Appearance Review Board Staff Report

ARB2022-10046

Request for a certificate of appearance approval for a 33 story mixed used building.

Pine and Lake Mixed Use Tower 319 E Church St. Final Review

Levels 17-18

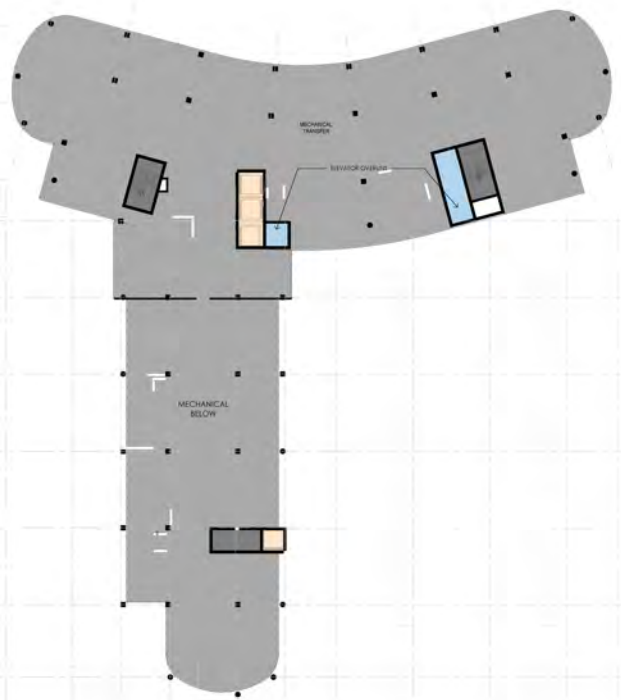
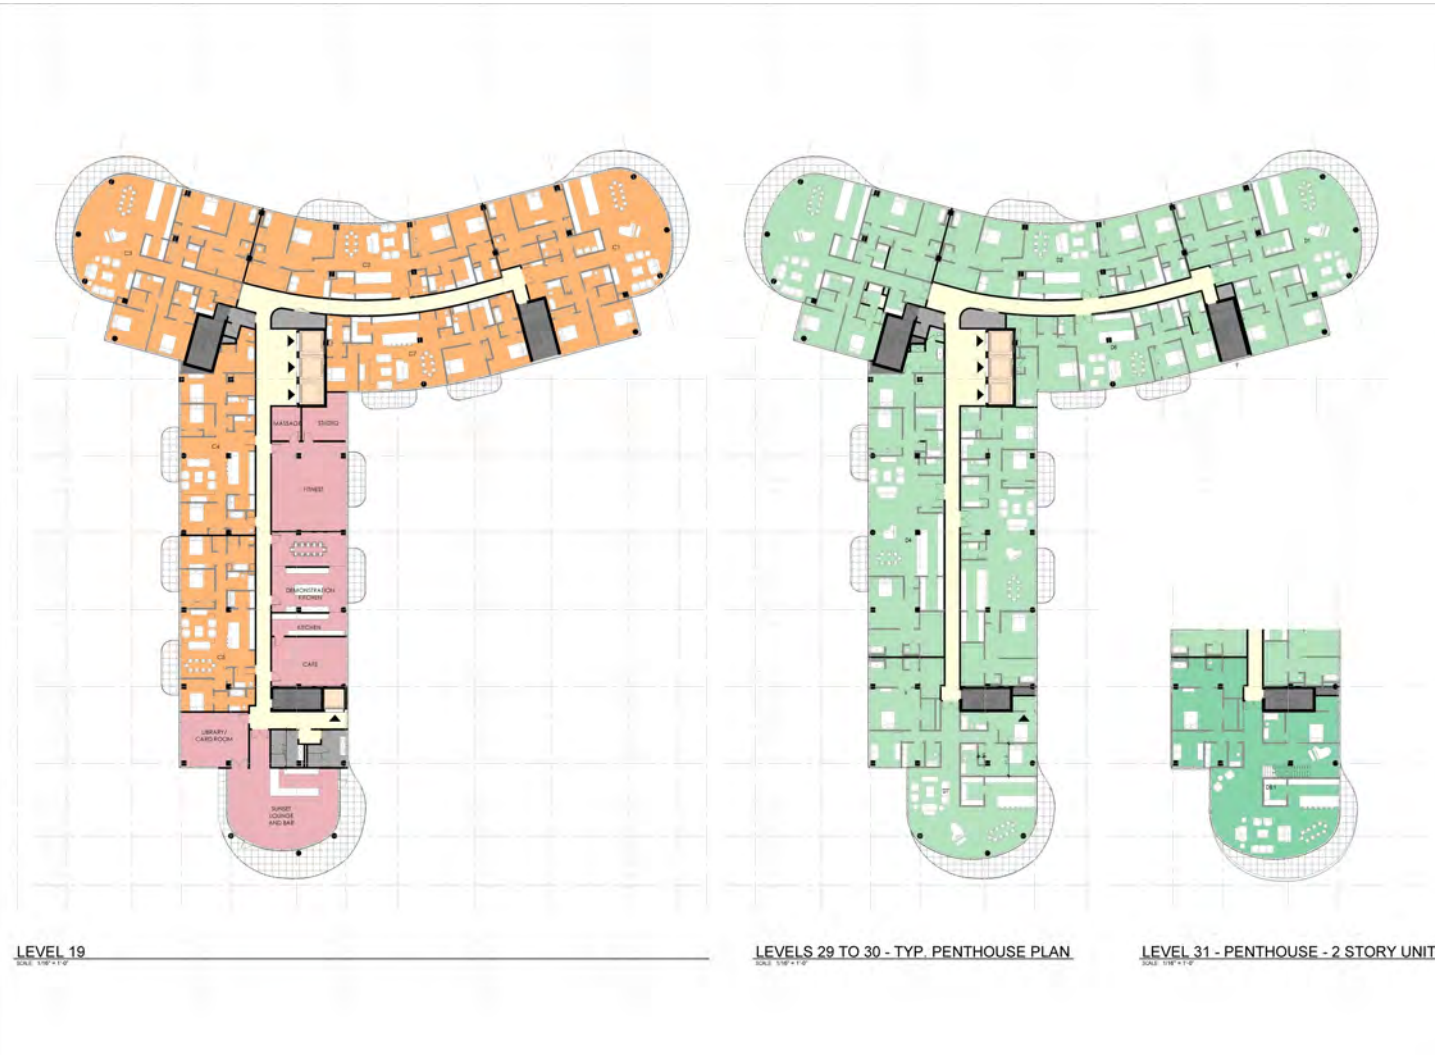
Mechanical Levels 17-18- this area is clad in a metallic finish fiber cement product and needs clarification on how that will mesh with other materials.

North Elevation-Pine Street

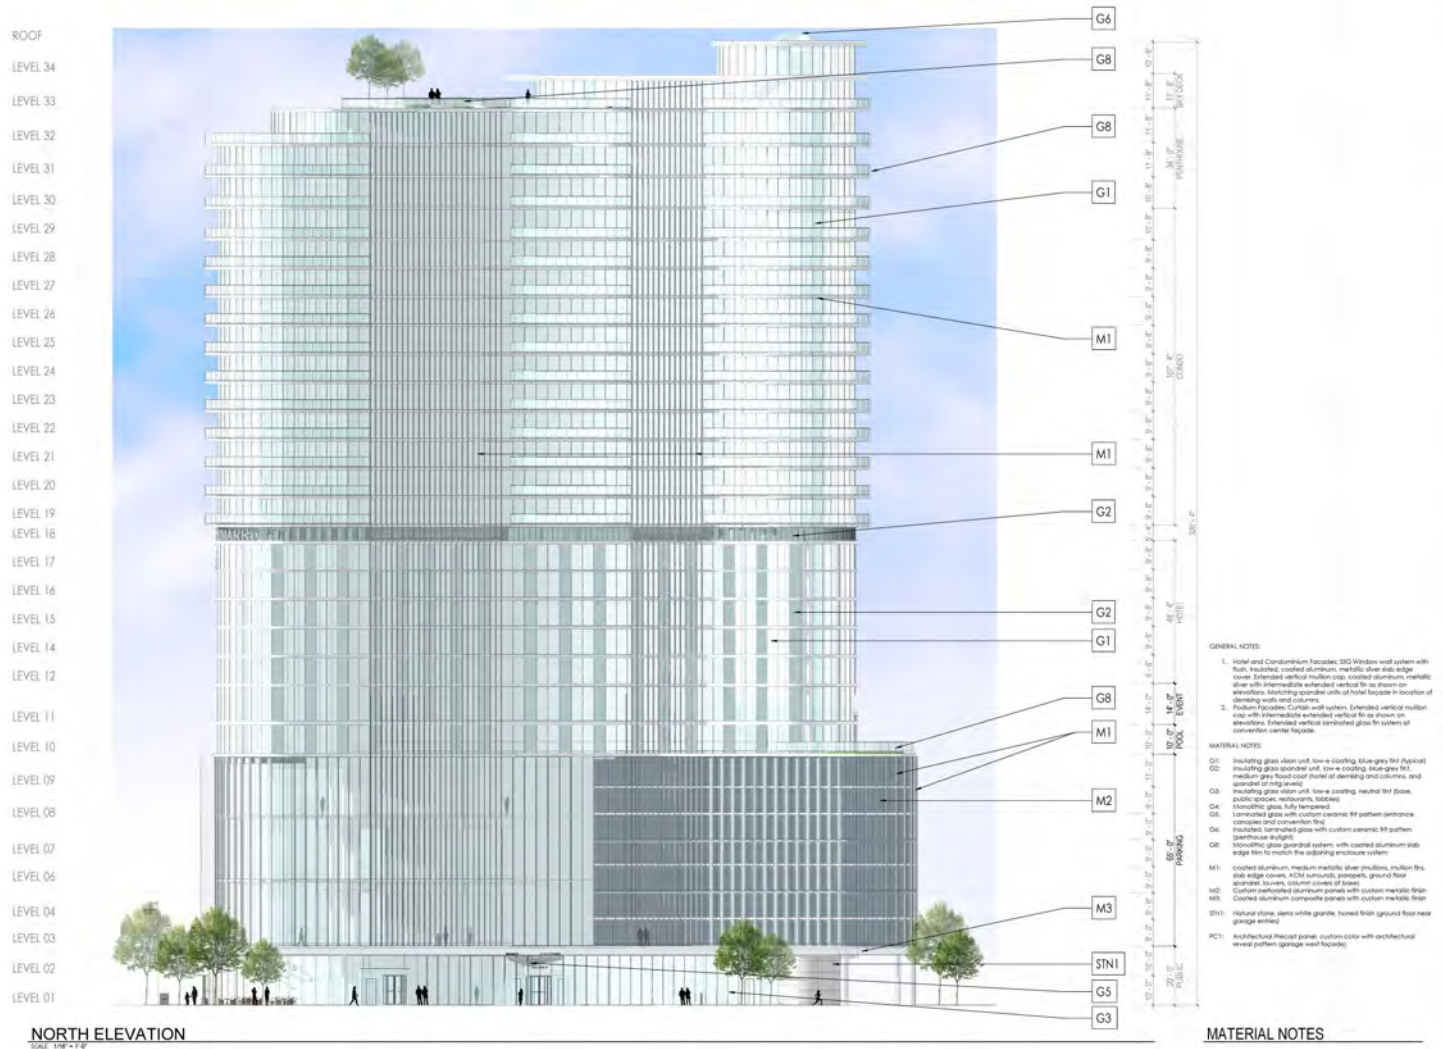
East Pine Street forms the northern edge of the site and at this point the street right of way is narrow. A dedicated cycle track is planned for the south Site of Pine Street and the new development must accommodate these plans. A 15 foot streetscape is needed on Pine and plans show that generally there is 15 feet except for a minimal pinch point at the western and eastern edges of the site where the building extends over approximately a foot into the required area at 21 feet above the sidewalk. The canopy shown on Pine Street extends far into the travel lane and appears to offer little protection.

Condo entrance canopy may not provide enough protection.

- a. East Pine Street requires a modified 15 foot wide treatment 4 with paving to back of curb. Street Trees – High-rise or cathedral live oaks shall be used as canopy trees where applicable. East Pine Street must also accommodate the future cycle track that will be located on the south side of Pine Street. Modifications to the Pine Street Streetscape shall require additional staff review.

3. Principal Entrances. Each use enters on a separate façade and each entry has a special canopy. The canopies shall meet LDC 61.204 and not project closer than 24 inches from the back of curb or create a rain runoff issue onto the sidewalk.

South Elevation-Church Street

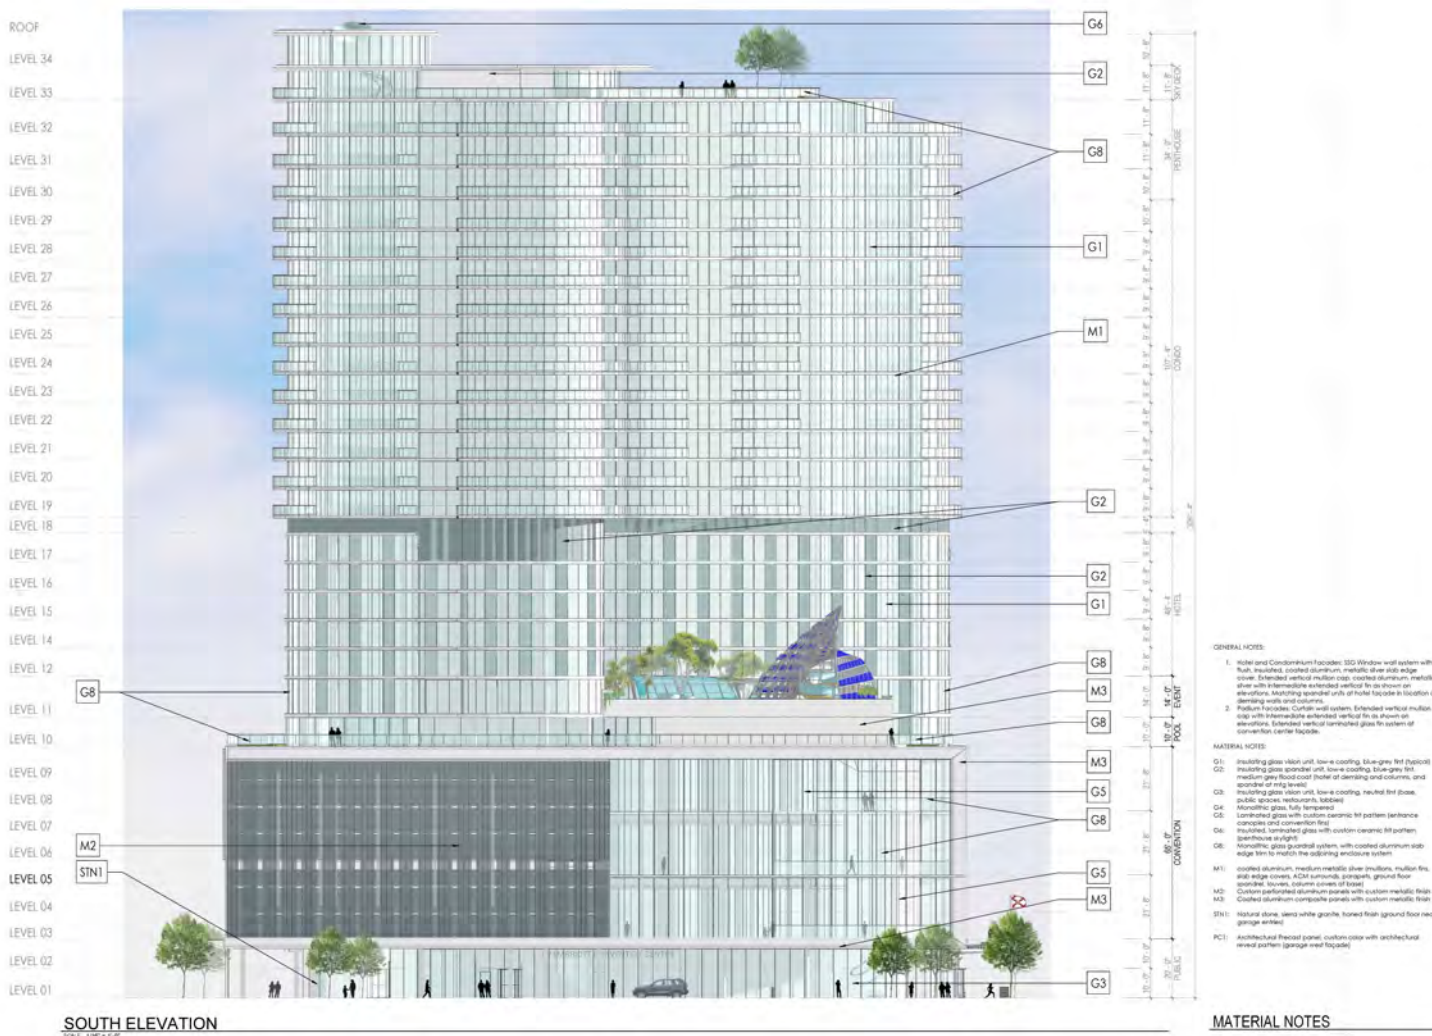
West elevation of podium on south edge at Church Street.

- d) The slope of the grade preceding the exit of a parking garage shall not exceed 2% for a minimum of 25 feet.
- e) Finished screening material shall wrap around from the Church Street façade onto the west wall of the garage a minimum of 20 feet.
